RESOLUTION NO.: 2008- 72

A RESOLUTION OF THE BOARD OF SUPERVISORS OF PIMA COUNTY, ARIZONA; RELATING TO PLANNING; AMENDING COMPREHENSIVE PLAN REGIONAL PLAN POLICY 3, WATER RESOURCES ELEMENT, FOR ALL OF PIMA COUNTY.

Water Resources

SUBJECT: Co7-08-02 Monument West Estates L.L.C.

Aerial View

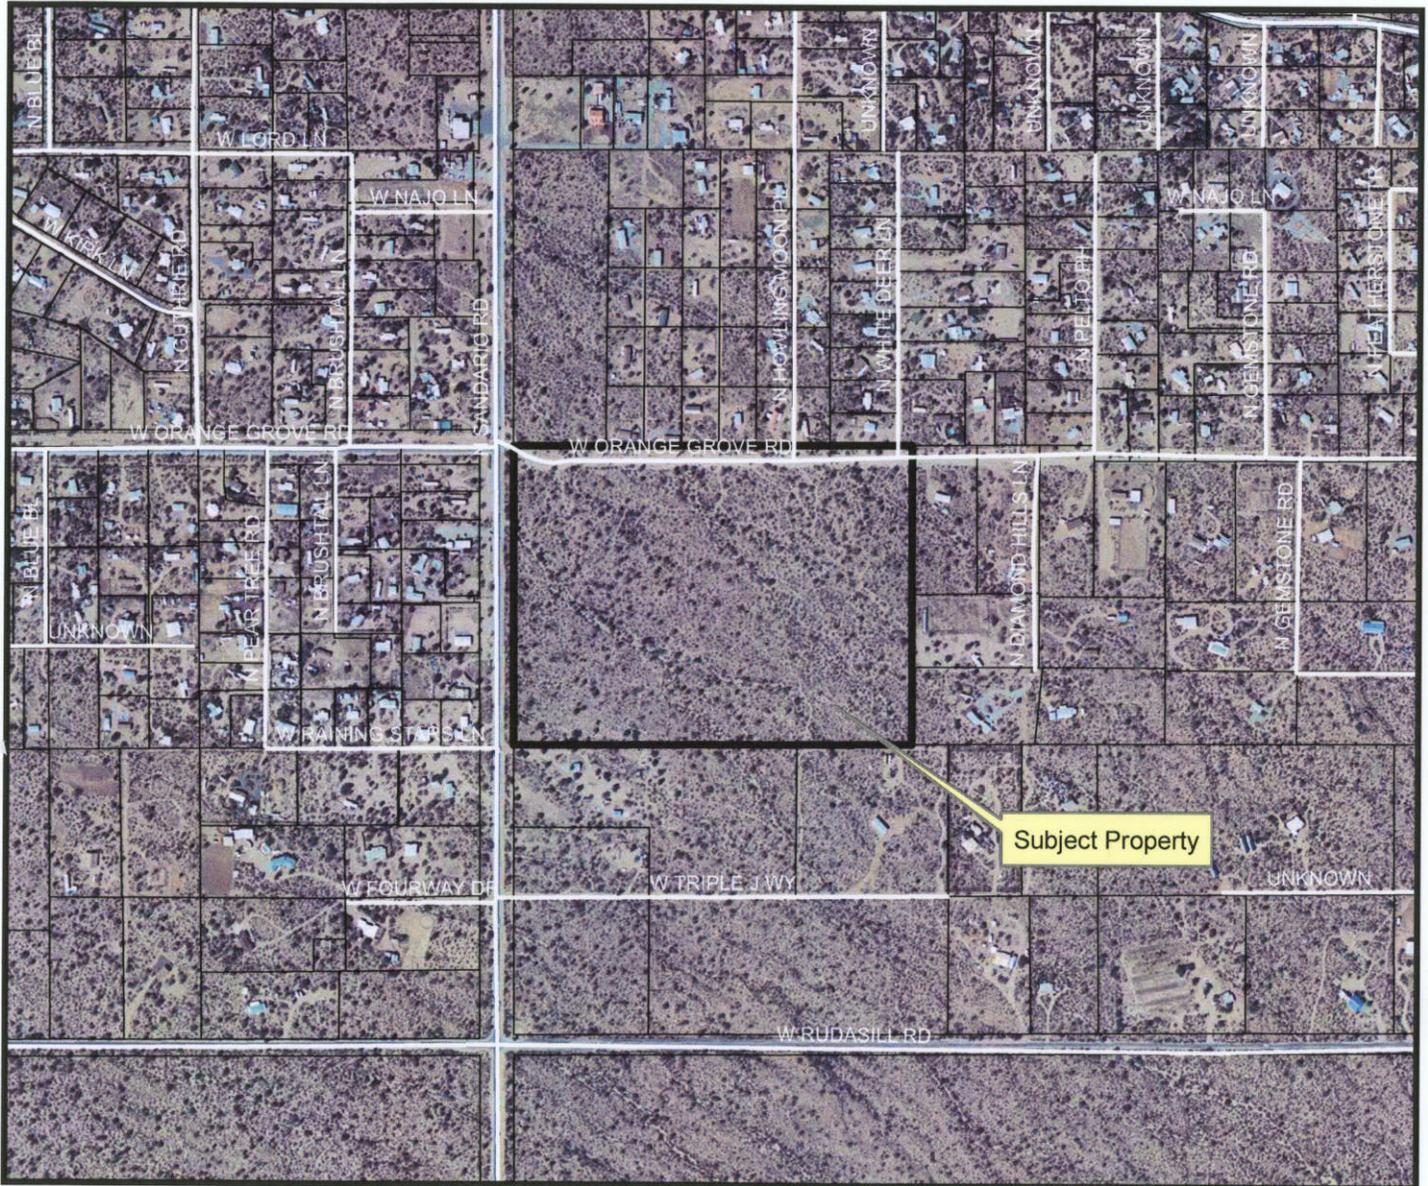
Pima County's Water Supply Impact Analysis finds that this Plan Amendment does not presently have access to renewable and potable water. However, it is in an area where groundwater has been recovering and is projected to continue to recover.

Based on this analysis, we recommend **the following as a Rezoning Policy** should the Board of Supervisors approve this plan amendment:

- The applicant should be encouraged to participate in the Central Arizona Groundwater Replenishment District (CAGRDR) to replenish water use. Replenishment will likely occur at LSCR, 5 miles downstream, unless CAGRDR can arrange to recharge in CAVSARP due to its proximity to the AWC. The applicant is requested to discuss in writing with CAGRDR their desire to have their replenished water recharged at CAVSARP.

Aerial Map

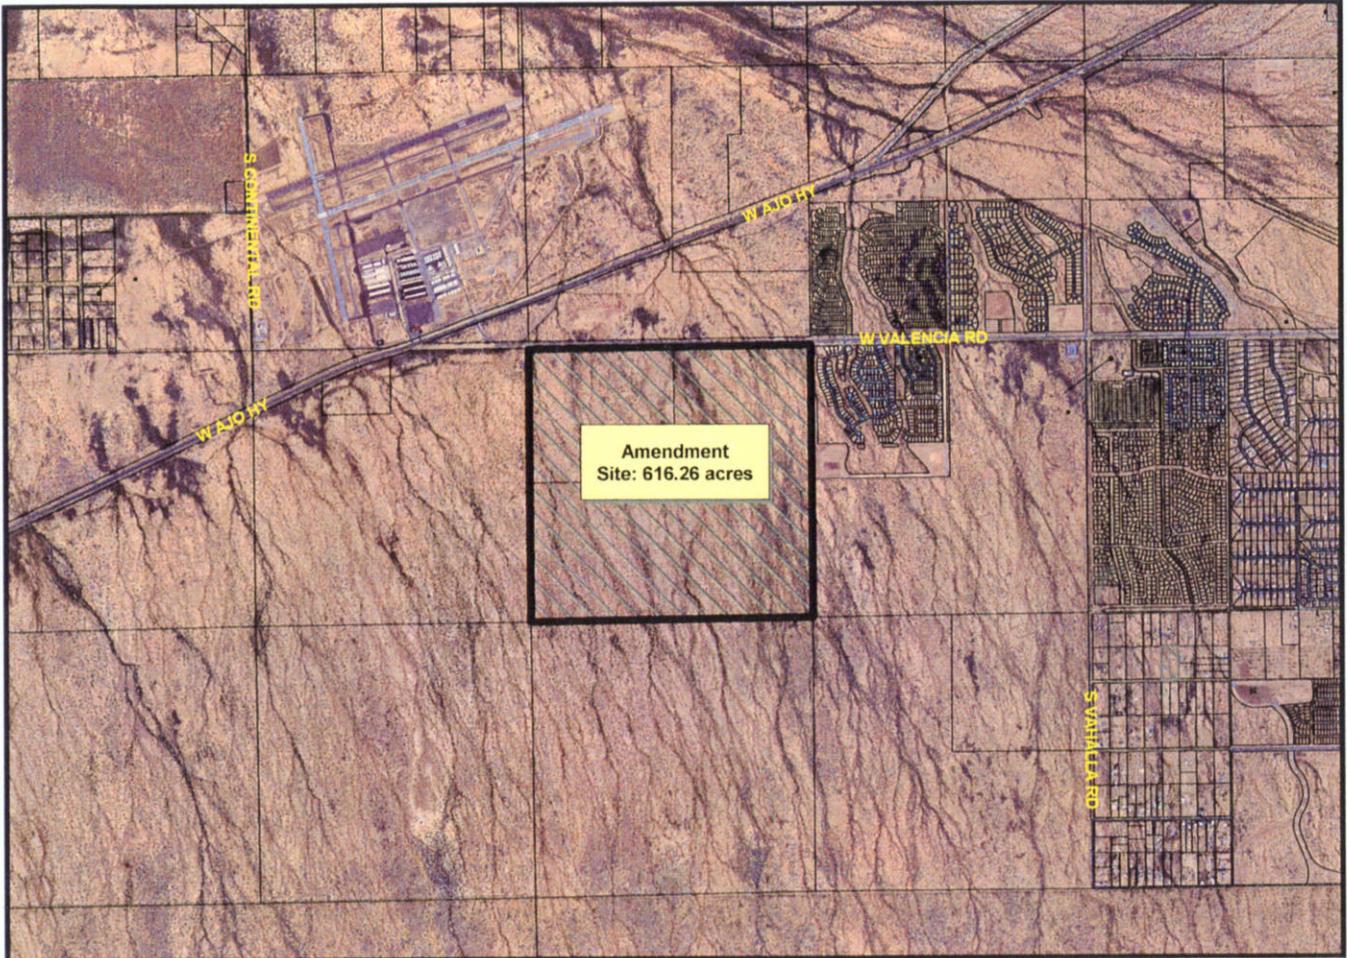
Pima County's Water Supply Impact Analysis finds that this proposed Specific Plan, under current conditions, **does not presently have potential access to renewable and potable water unless it receives a supply from TW**. It is in an area where groundwater has been declining and is projected to continue to decline. In addition, subsidence has been high. If the applicant joins the CAGR, the CAP water recharged for the proposed specific plan area will be over 20 miles hydrologically downgradient of the site and will not provide direct replenishment in the area of hydrologic impact.

Based on this analysis, we recommend **the following as a Rezoning policy** should the Board of Supervisors approve this Specific Plan:

- A letter of intent to serve from a water service provider shall be submitted as part of any subsequent actions. If the letter of intent to serve is from a water service provider that does not have access to a renewable and potable water supply, the applicant will provide documentation as to why a water service provider with access to a renewable and potable water source is not able to provide service.
- The applicant has stated in the specific plan proposal that a Preliminary Integrated Water Management Plan (PIWMP) will be provided. The applicant will at the second tier of Design Standards for Pomegranate Farms, provide water conservation methods and quantify the water savings as part of the PIWMP.

SISTERS OF IMMACULATE HEART OF MARY

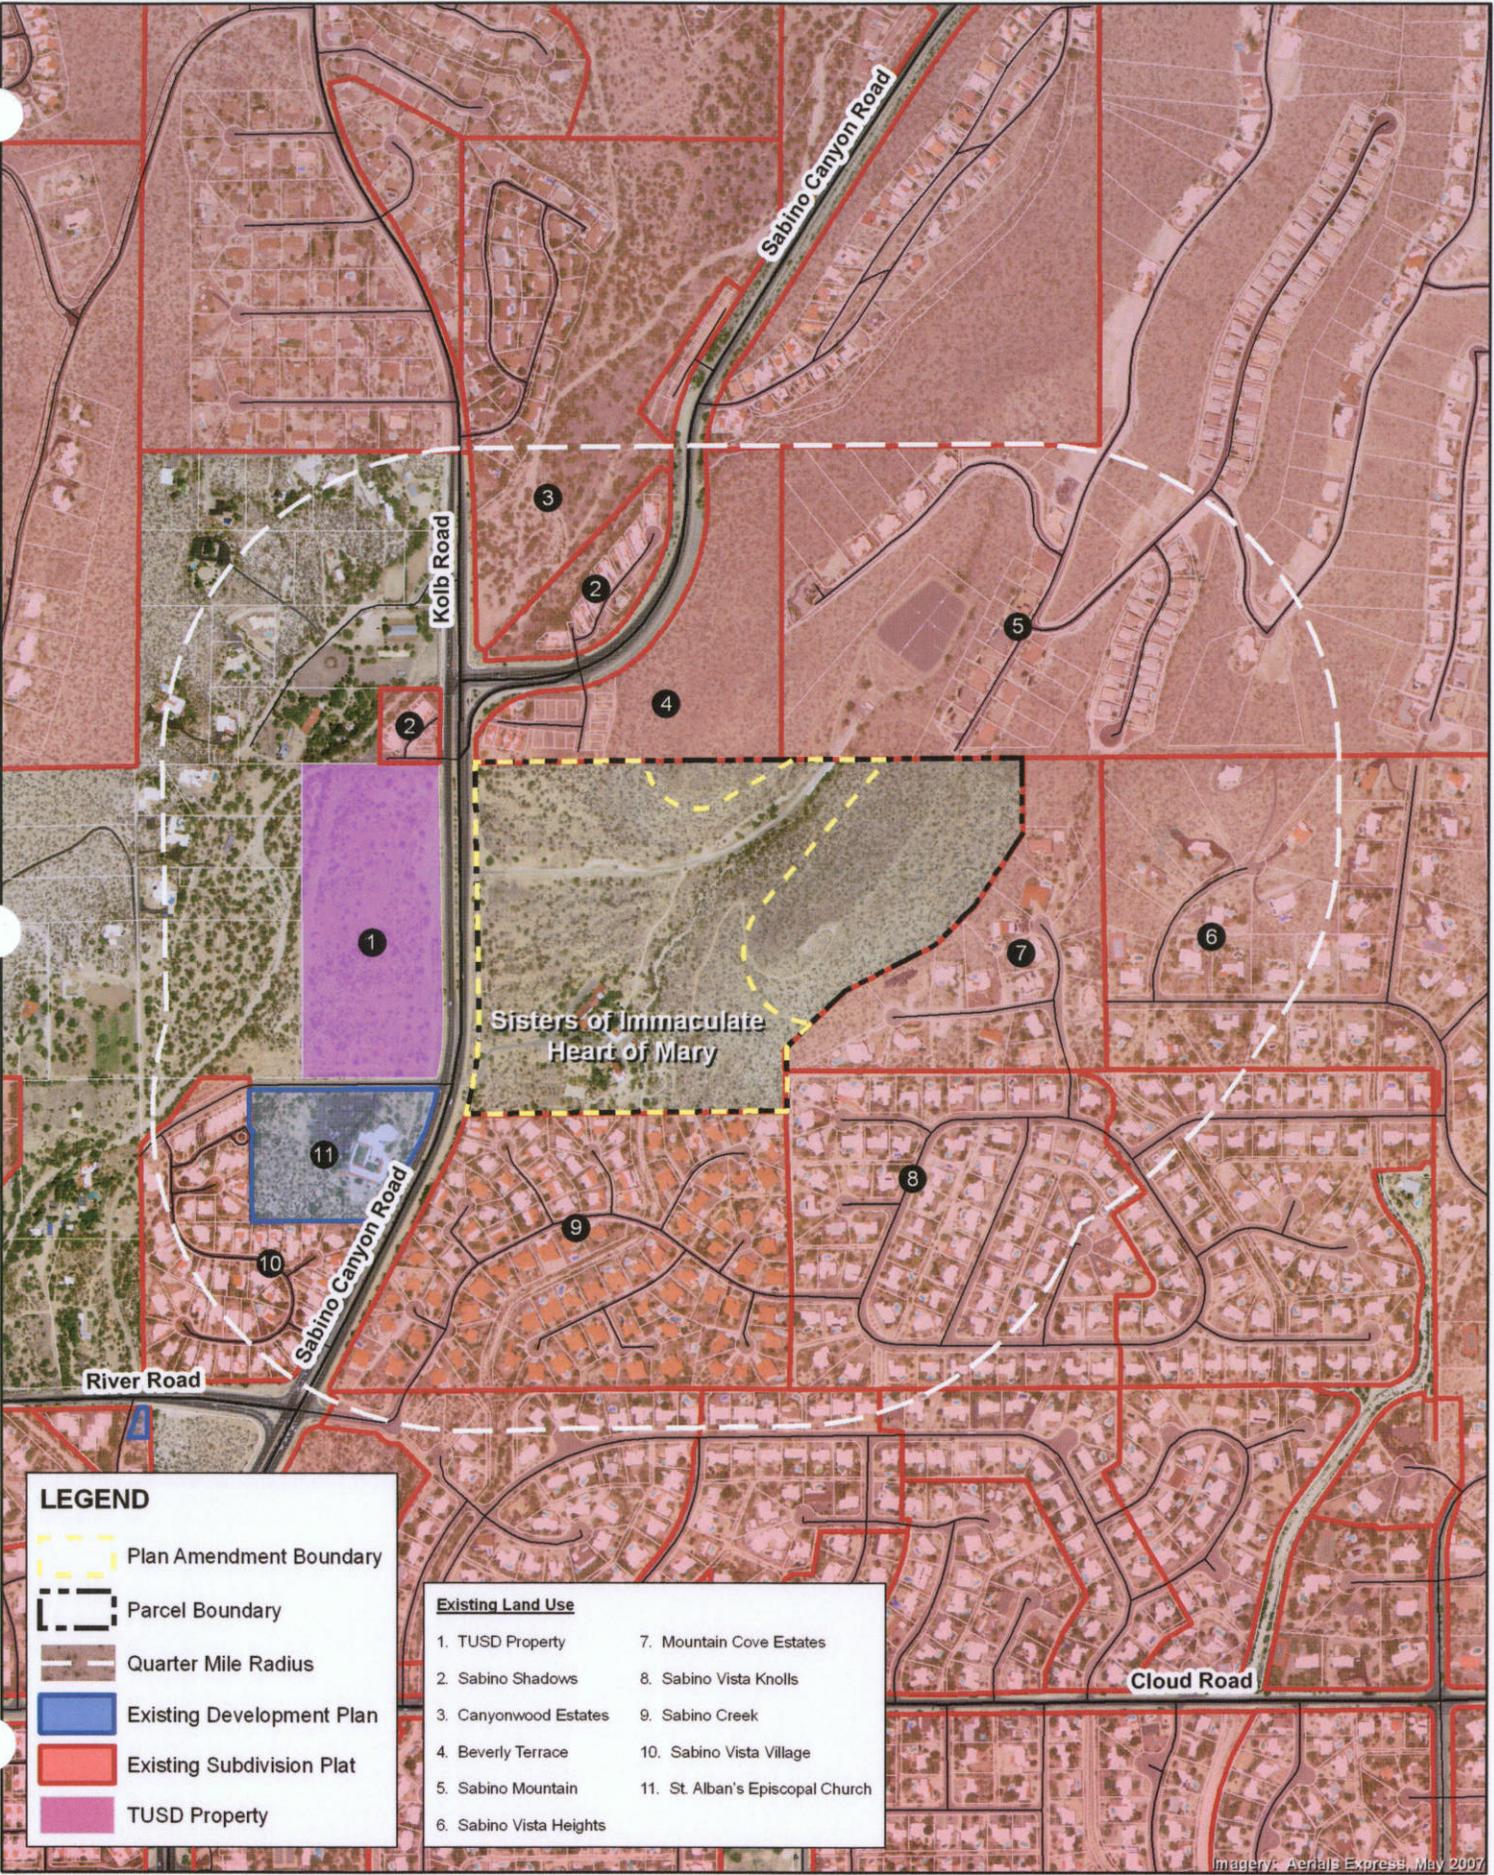
Pima County's Water Supply Impact Analysis finds that, under existing conditions, the Plan Amendment property does not have access to renewable and potable water unless MDWID uses its interconnect with Tucson Water in this area. Tucson Water may in the future provide more water that is from a renewable source when infrastructure can boost the Avra Valley groundwater–CAP blend (Clearwater) to the area. For now, groundwater and the Clearwater blend will be provided for the area.

The proposed amendment area is close to (1/2-mile) a groundwater dependent ecosystem. The area is also where groundwater has been declining but is projected to recover as Tucson Water reduces pumping from area wells and provides more Clearwater blend.

Based on this analysis, we recommend **the following as a Rezoning policy** should the Board of Supervisors approve this plan amendment:

- A letter of intent to serve from a water service provider shall be submitted as part of any subsequent rezoning application. If the letter of intent to serve is from a water service provider that does not have access to a renewable and potable water supply, the applicant will provide documentation as to why a water service provider with access to a renewable and potable water source is not able to provide service.

Aerial Photo (2006)

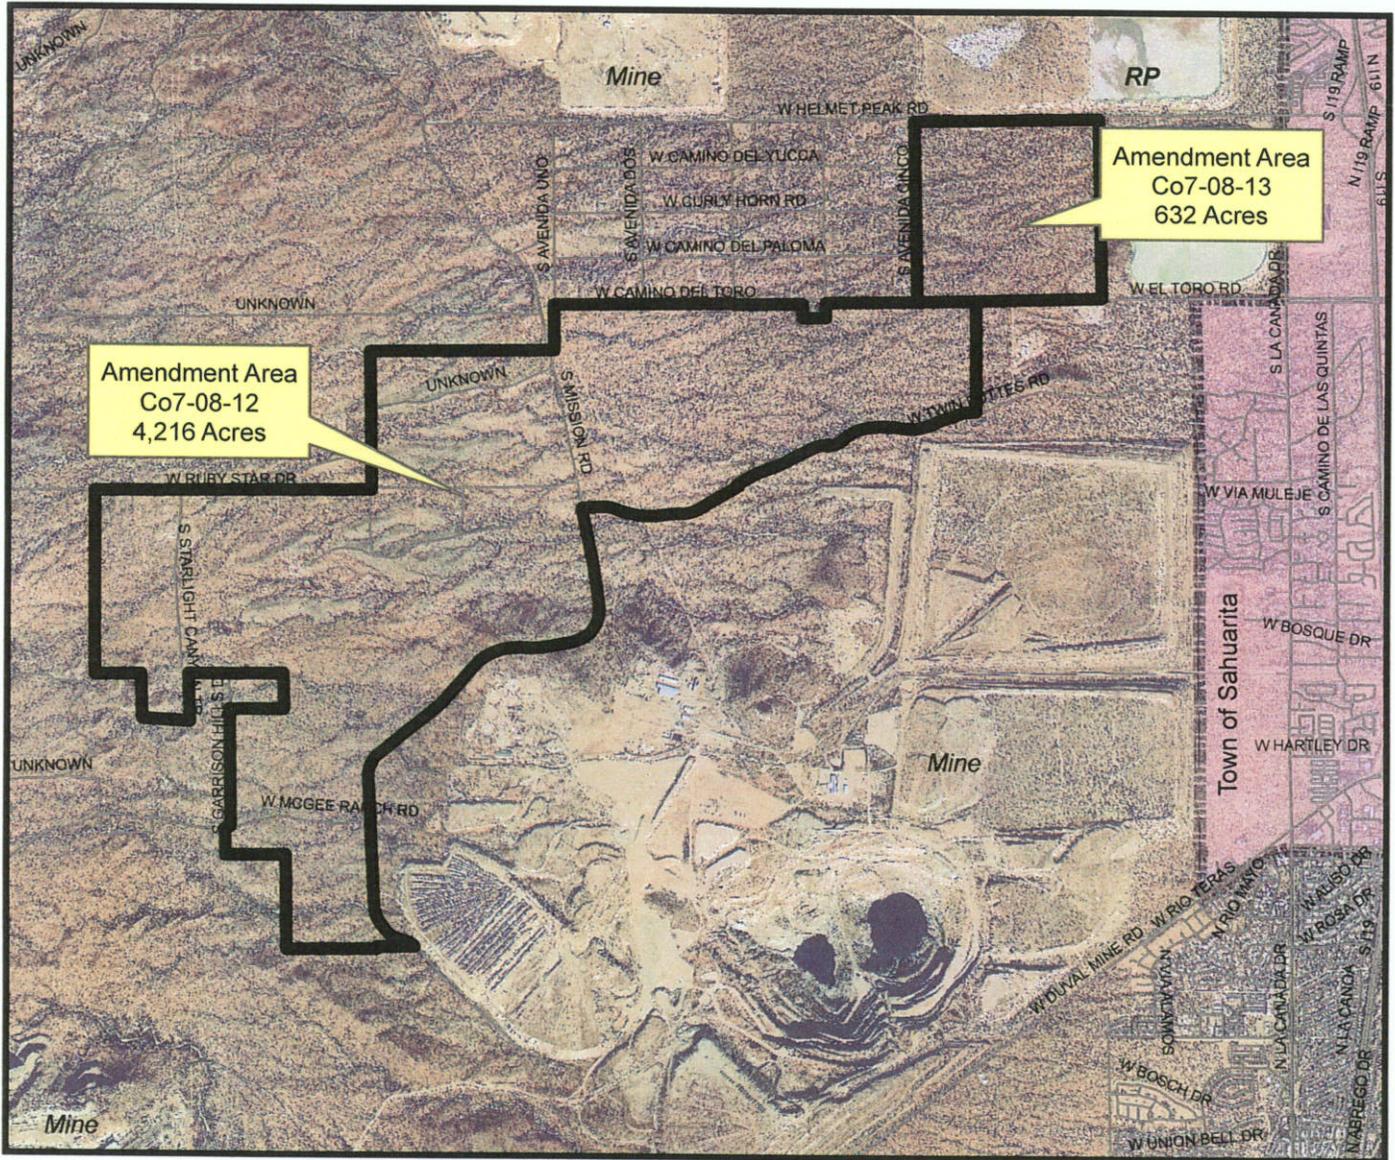
Pima County's Water Supply Impact Analysis finds that this General Plan Amendment does not presently have access to renewable and potable water. It is in an area where groundwater has declined and is projected to decline. The site lies within five miles of the Sid Simpson spring, a groundwater dependent spring located in the Sierrita Mountains. However, it is not clear where the source of water for the site will be located.

Based on this analysis, we recommend **the following as a Rezoning Policy** should the Board of Supervisors approve this plan amendment:

- Discussions continue to extend a CAP pipeline south through the Sahuarita Water Company service areas. The applicant should be encouraged to continue participation in the funding of a CAP pipeline to bring renewable and potable water to the area. Otherwise, this area will continue to be groundwater dependent with significant water-level declines.

- The applicant states that reclaimed water will be used for landscaping irrigation. They indicate a Wastewater Treatment Facility will be built for the site. A reclaimed water infrastructure currently does not extend to this area. Construction of the reclaimed system should be addressed now or in future land use planning actions.

- Low Intensity Development (LID) water harvesting should be incorporated into residential and commercial landscaping, paving, parking lots and park designs to encourage use of stormwater to irrigate exterior areas and conserve use of groundwater.
